**RE: 2103 Los Luceros Rd NW  
Grading and Drainage Plan  
Engineer's Stamp Date: 09/08/2025  
Hydrology File: H12D025  
Case # HYDR-2025-00324**

Based upon the information provided in your submittal received 12/27/2025, the Grading & Drainage Plan is approved for Building Permit, and Grading Permit. Please attach a copy of this approved plan in the construction sets for Building Permit processing along with a copy of this letter.

**GRADING AND DRAINAGE PLAN**  
2103 LOS LUCEROS ROAD NW  
ADRIAN OGLESBY

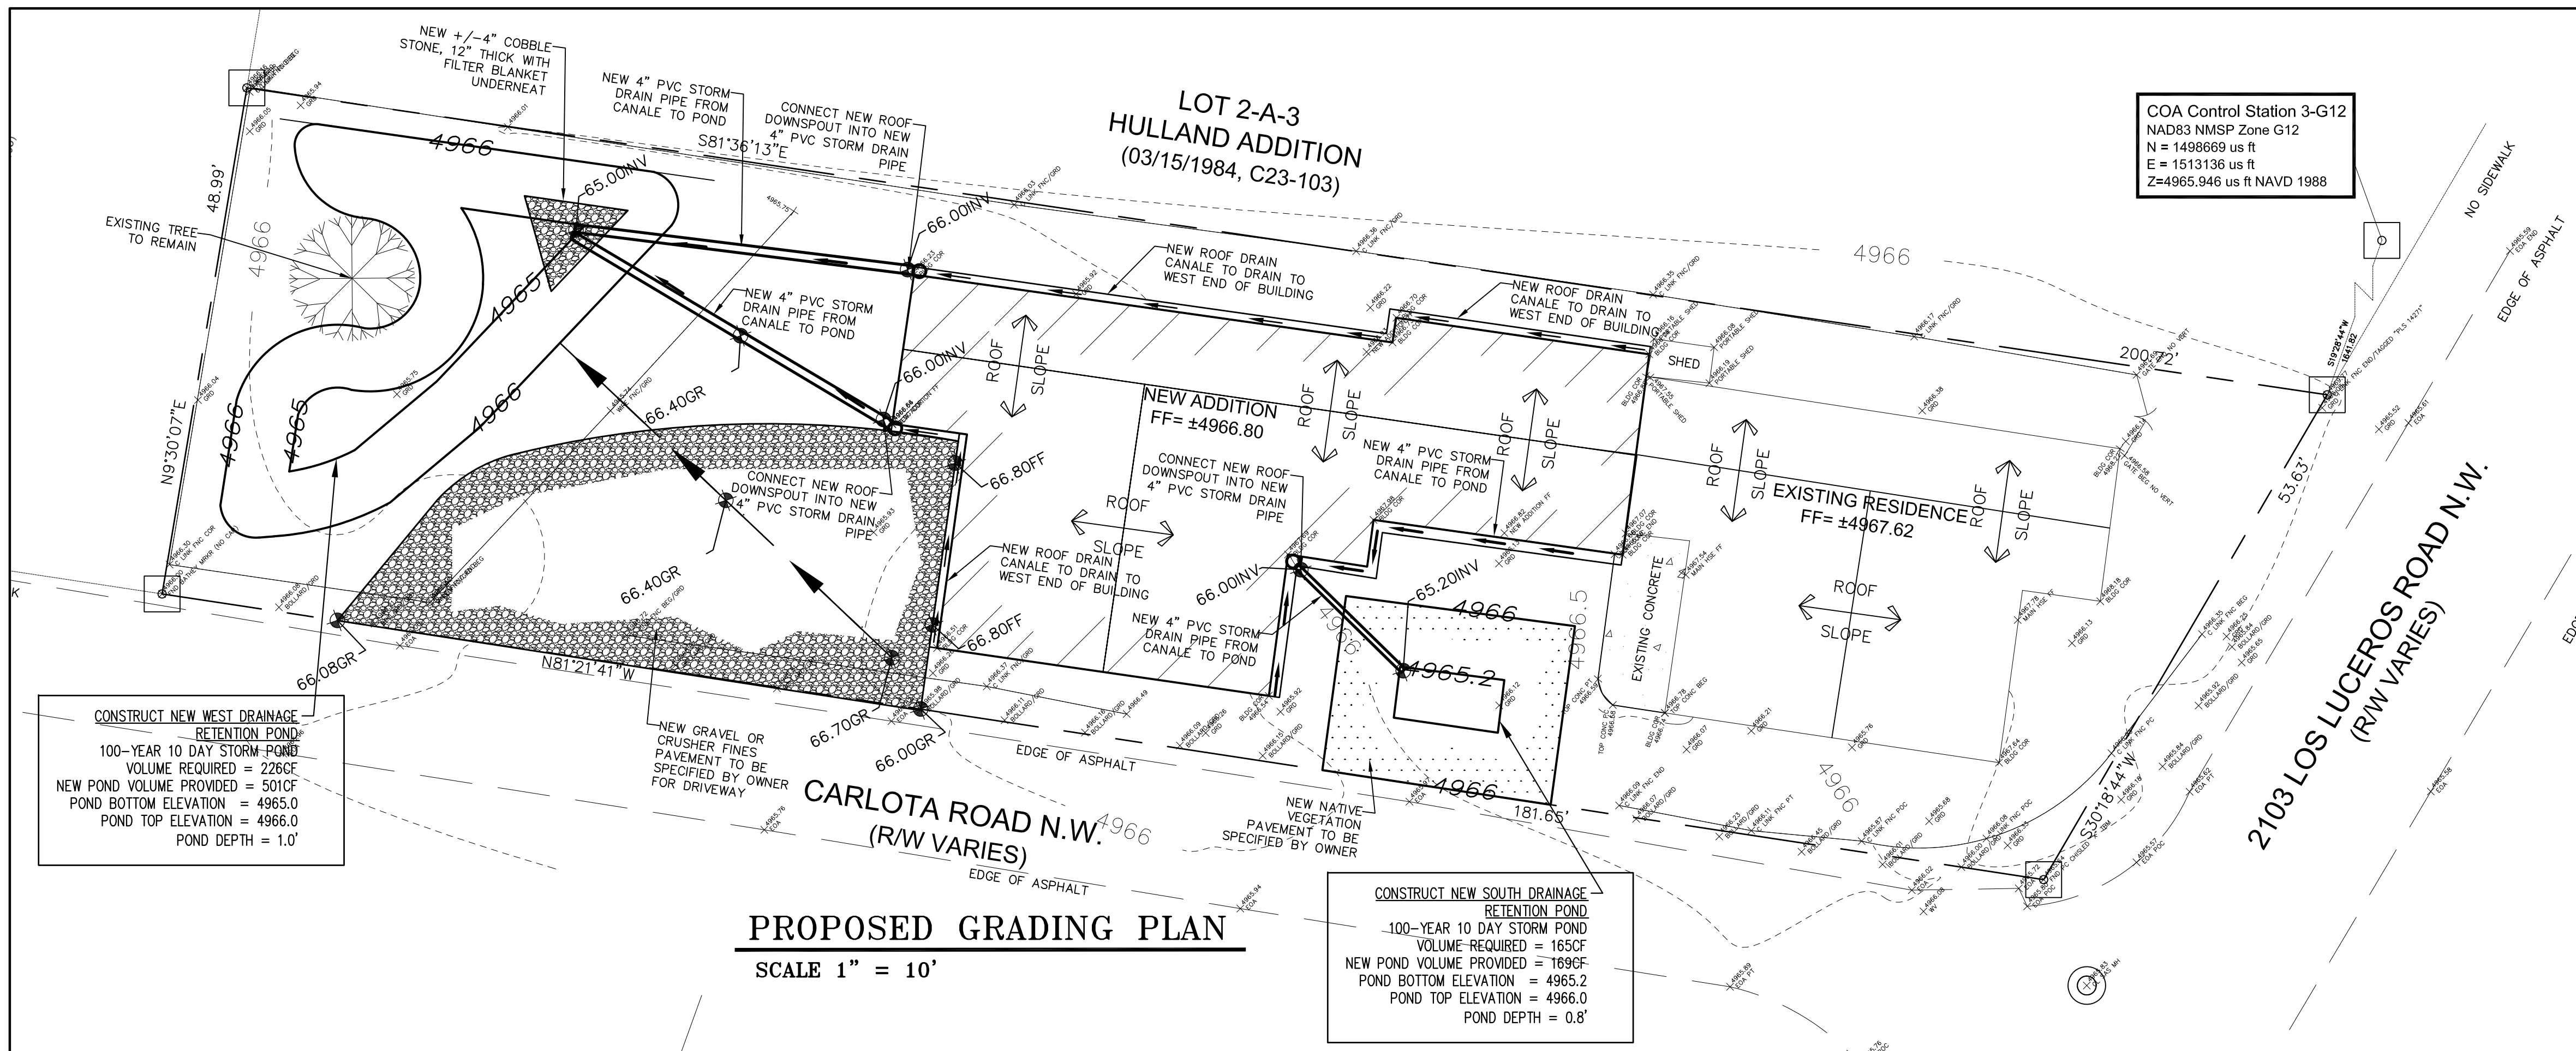
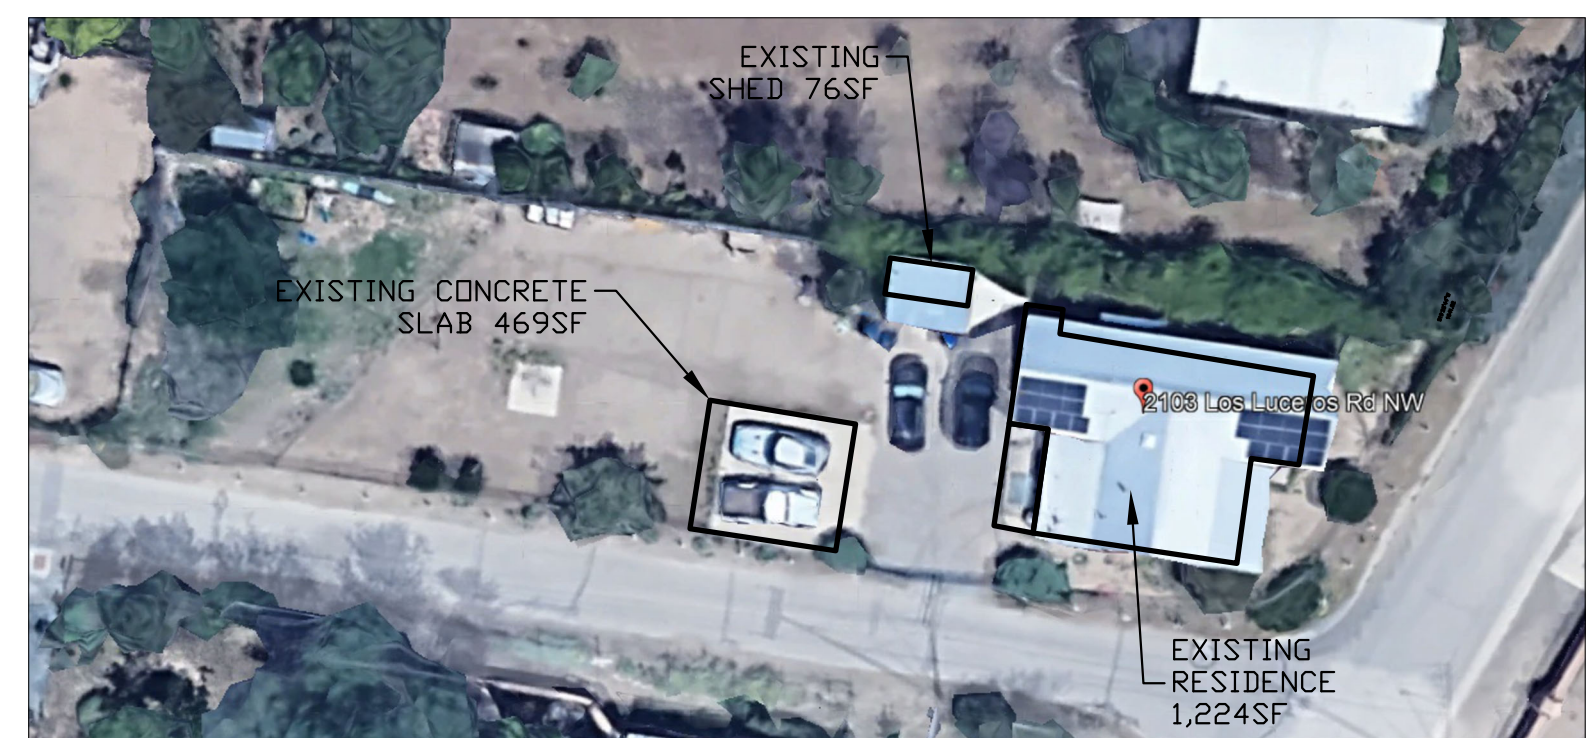
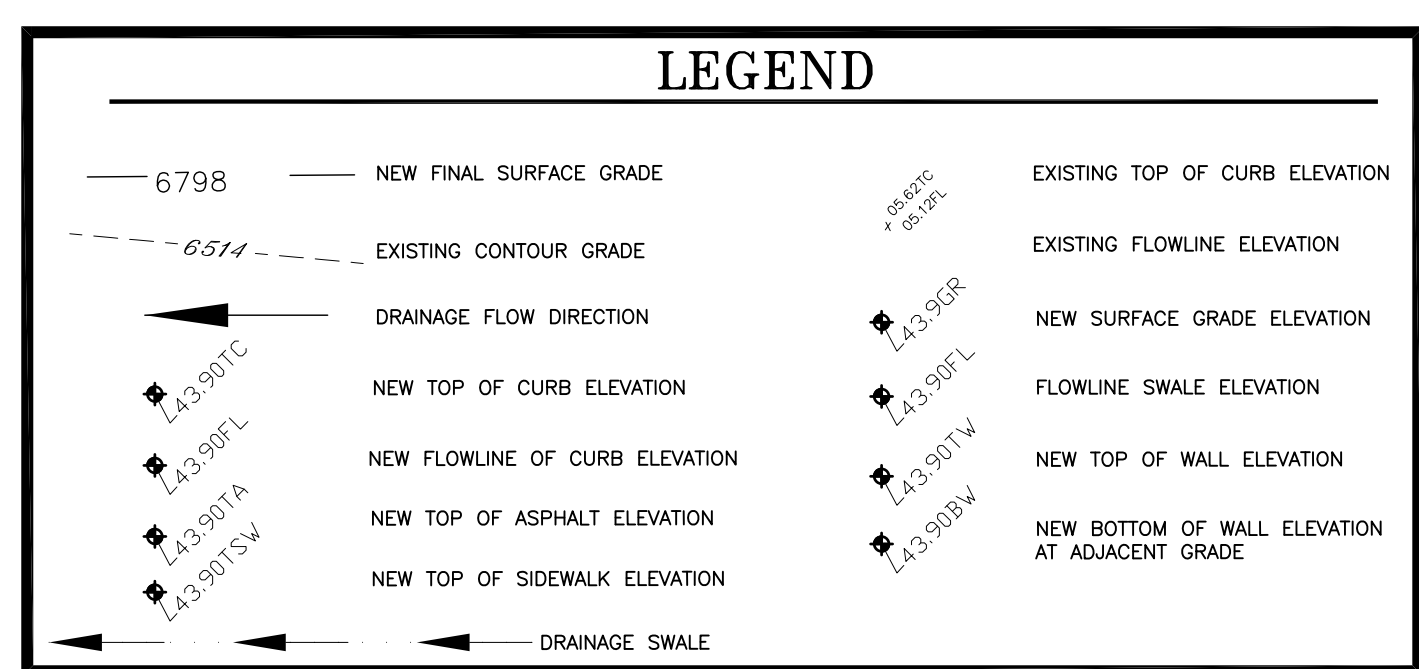
1. Engineer's Certification, per the DPM Part 6-14 (F): *Engineer's Certification Checklist For Non-Subdivision* is required.
2. Please provide the Drainage Covenant with Exhibit A for the stormwater quality ponds per Article 6-15(C) of the DPM prior to Permanent Release of Occupancy. Please submit the original copies along with the \$ 25.00 recording fee check made payable to Bernalillo County to the Hydrology Section of Development Review Services on the Ground floor of Plaza de Sol. Electronic submittal in ABQ-PLAN is also required.
